INFORMATION SHEET 10/13/15 TRUSTEES MEETING

ISSUE: RGM Associates Jefferson Change Order #'s and Traina Gymnasium Change Order #'s #021, #029-R1 and #030

RE: Anthony Traina Gym and Performance Center
DSA Appl. #: 02-113192
COR #021

APPLICATION FOR APPROVAL OF CONSTRUCTION CHANGE DOCUMENT - CCD CATEGORY A

tk1sc
COLLABORATIVE

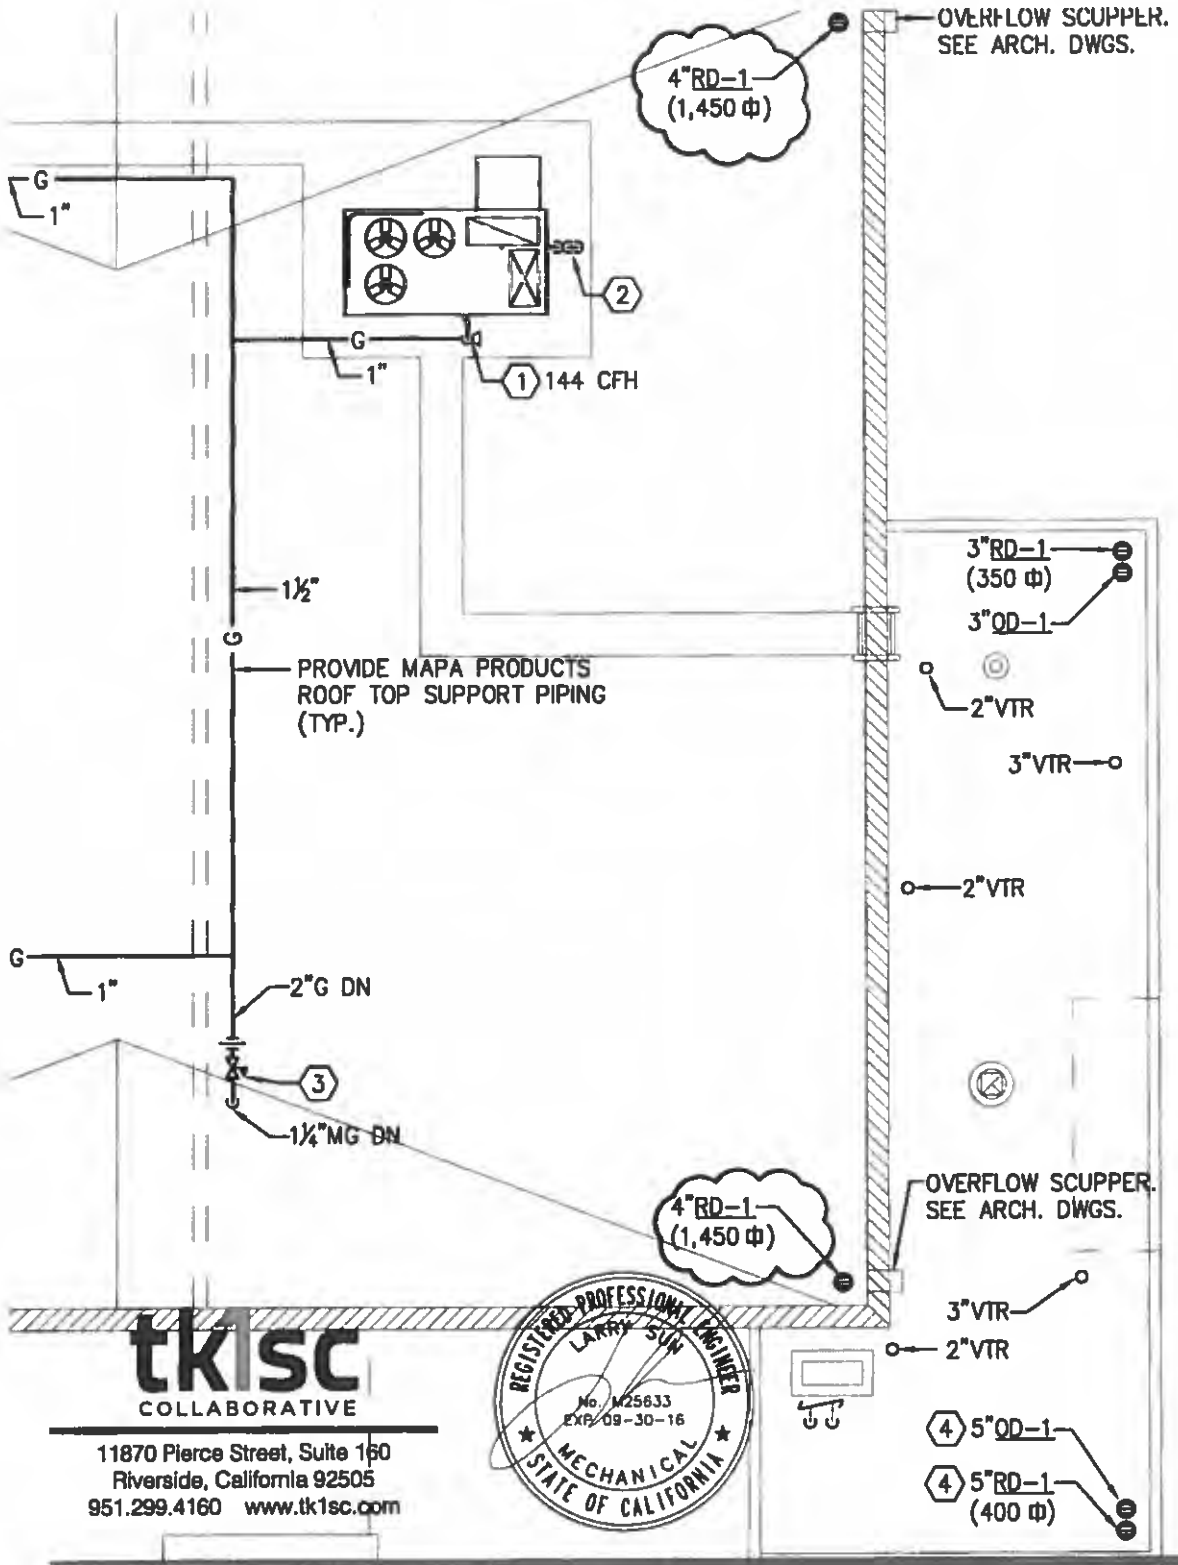
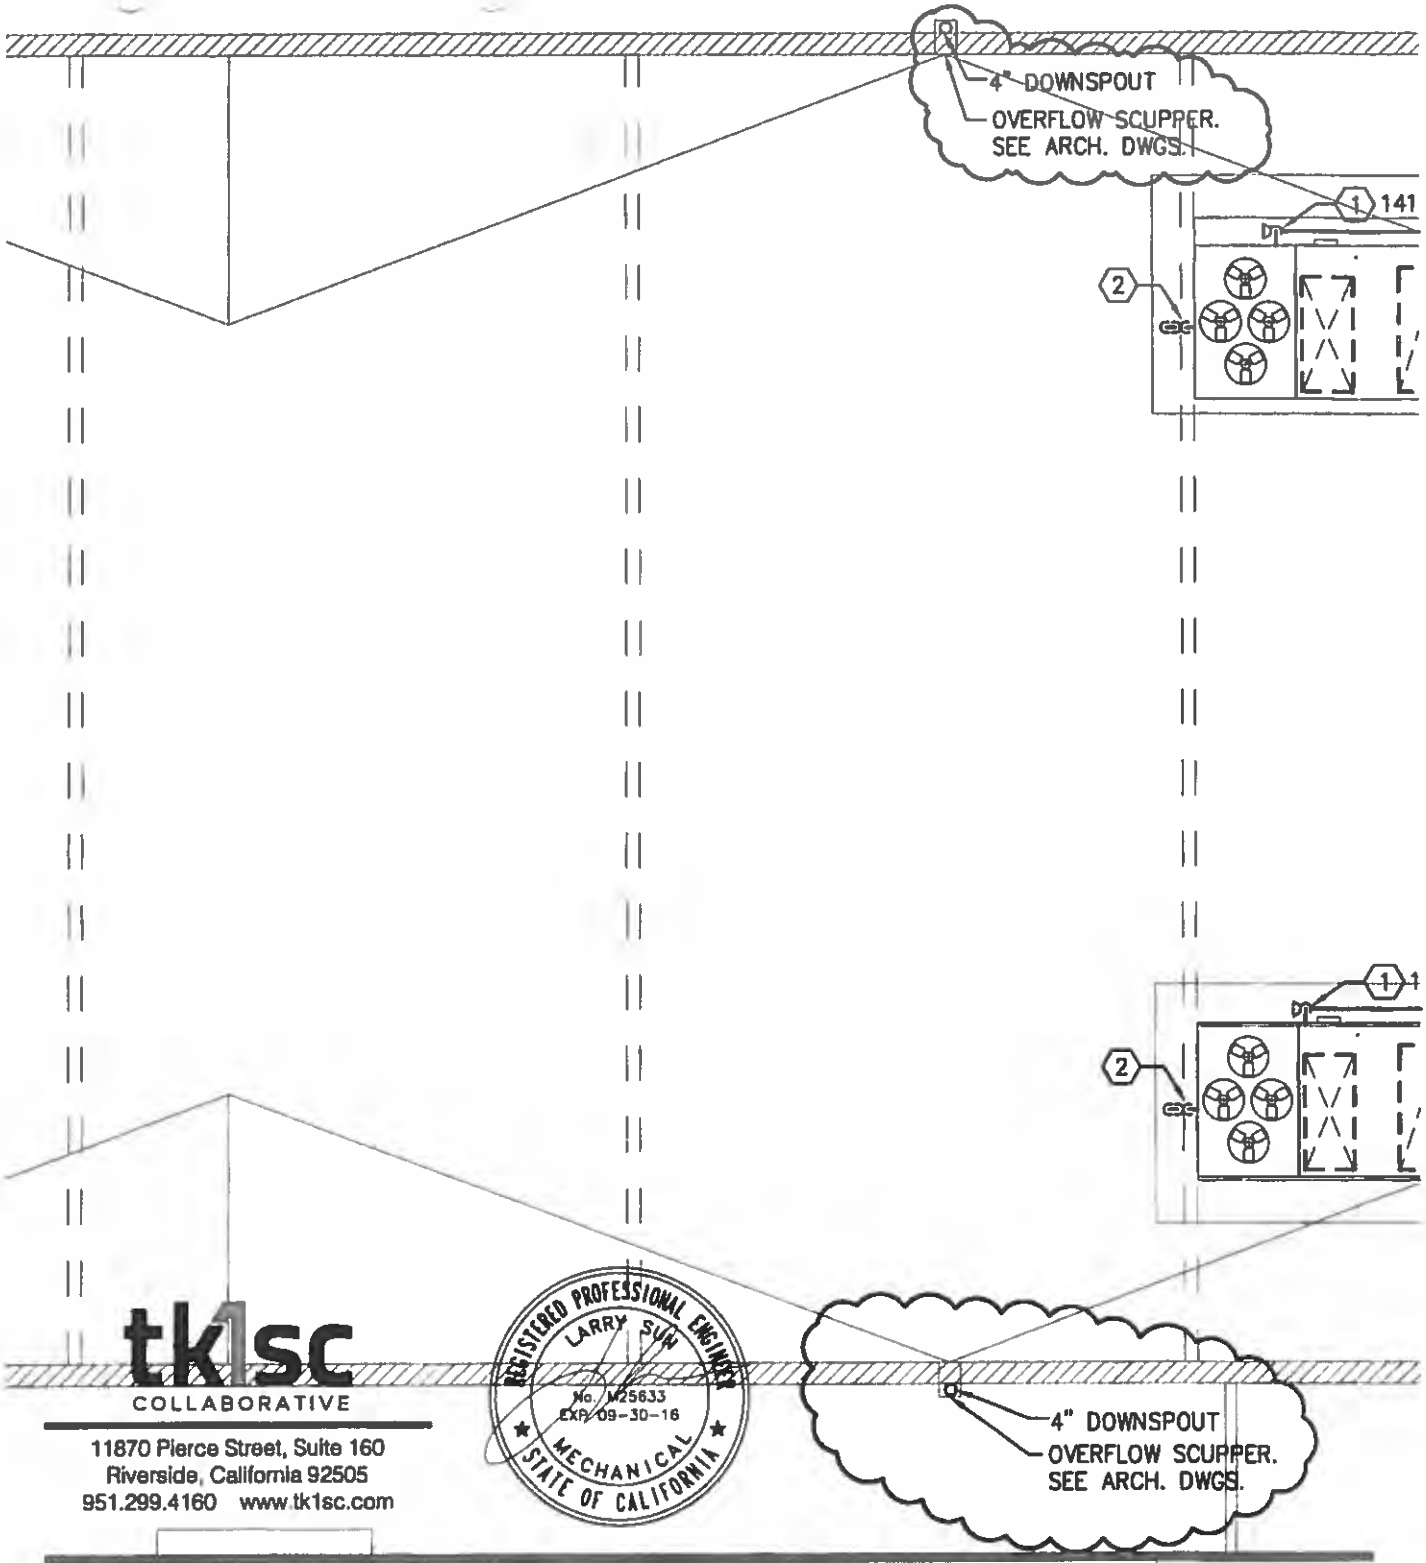
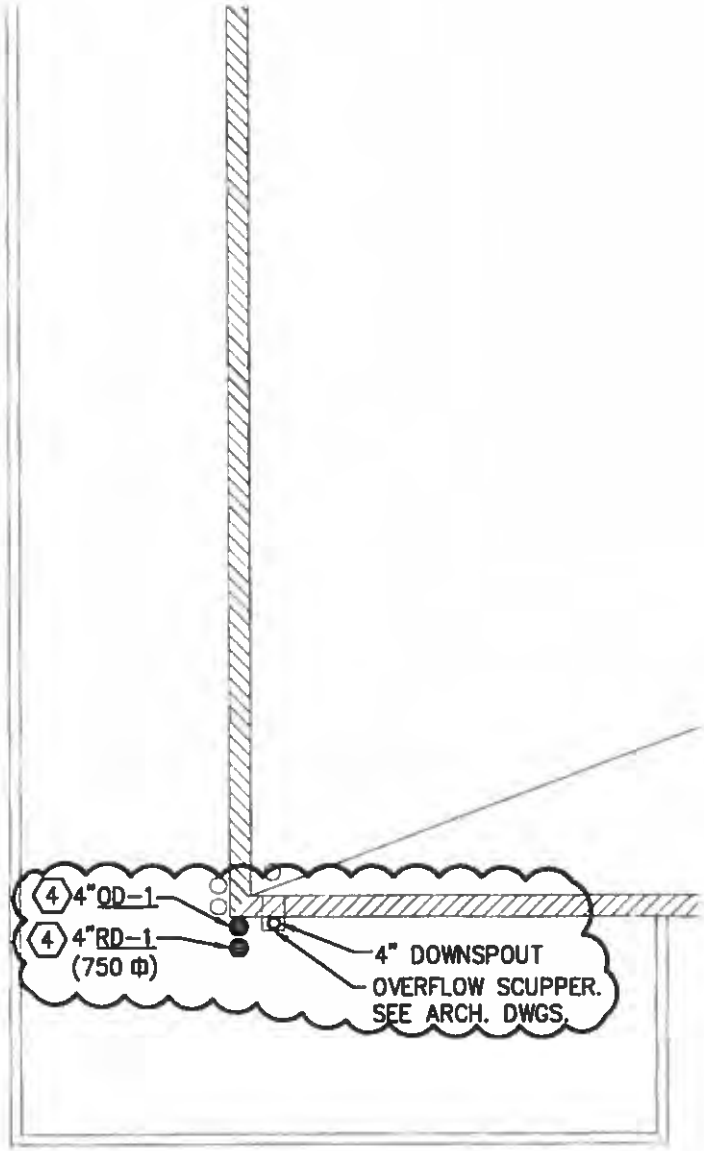
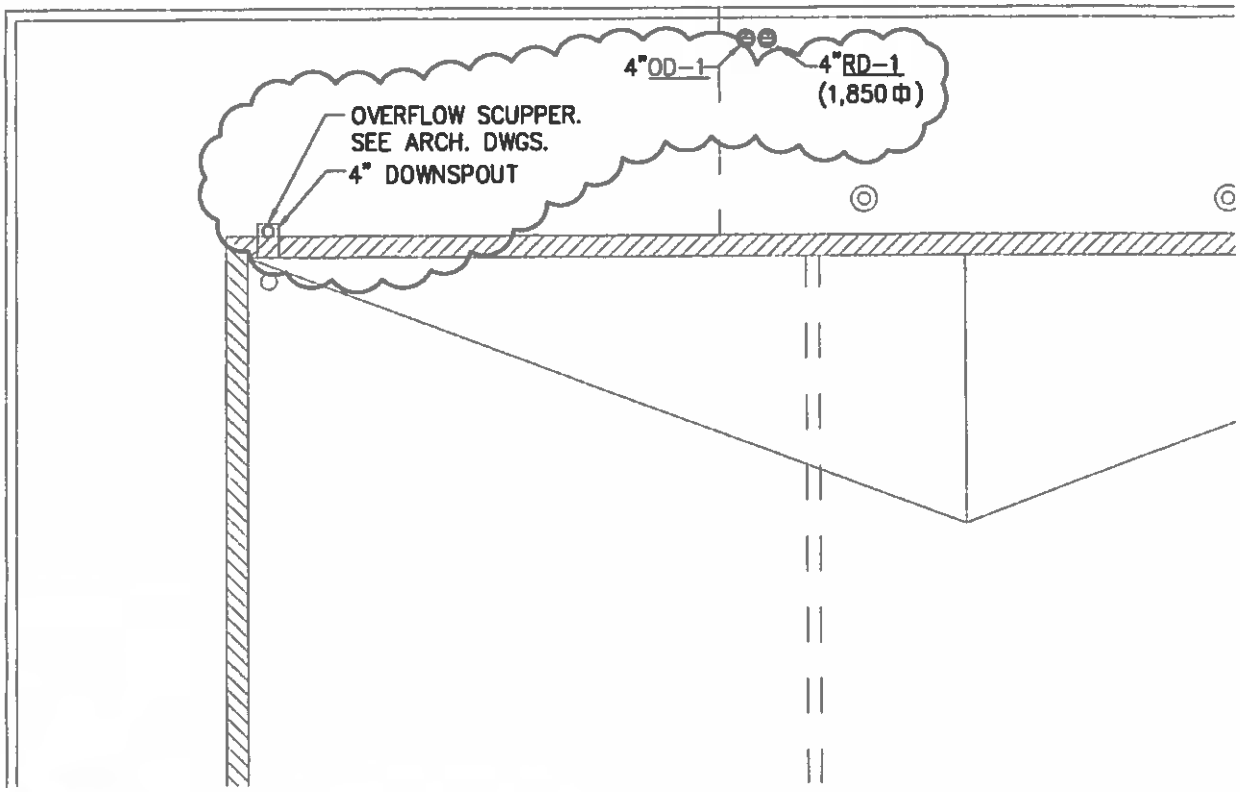
Notes: To replace roof drains with downspouts per detail SKA-1 through SKA-5, SKA-2 detail #8 & SKP-8. Add two additional roof drains and revise the storm drain connections.

Provide new storm drain connection per SKC-1. Revise the roof crickets from wood framed to rigid insulation and replace roof drains with collector box and downspouts per SKA-1 through SKA-5 . Add two additional roof drains and revise the storm drain connections per P-1 through P-8.

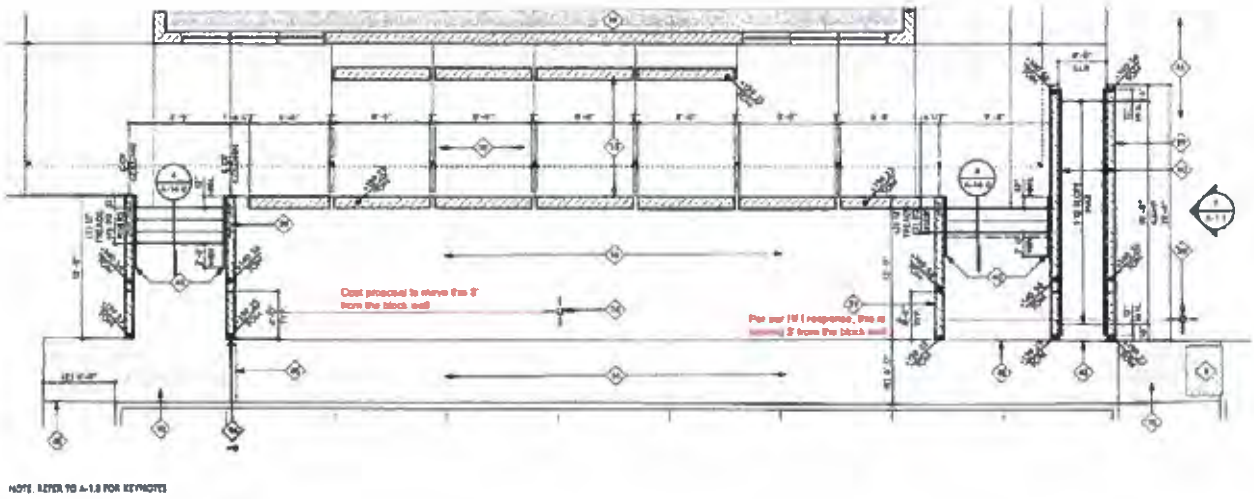
We were just looking for pricing right now and are not going to put together a CCD until there is actual direction to give. See attached sketch for the what we would like a cost proposal for…

I know we talked about the relocation of the site lighting at our meeting, but I need a formal CCD for this work showing the location of the relocated light so that we can proceed with pricing this work.
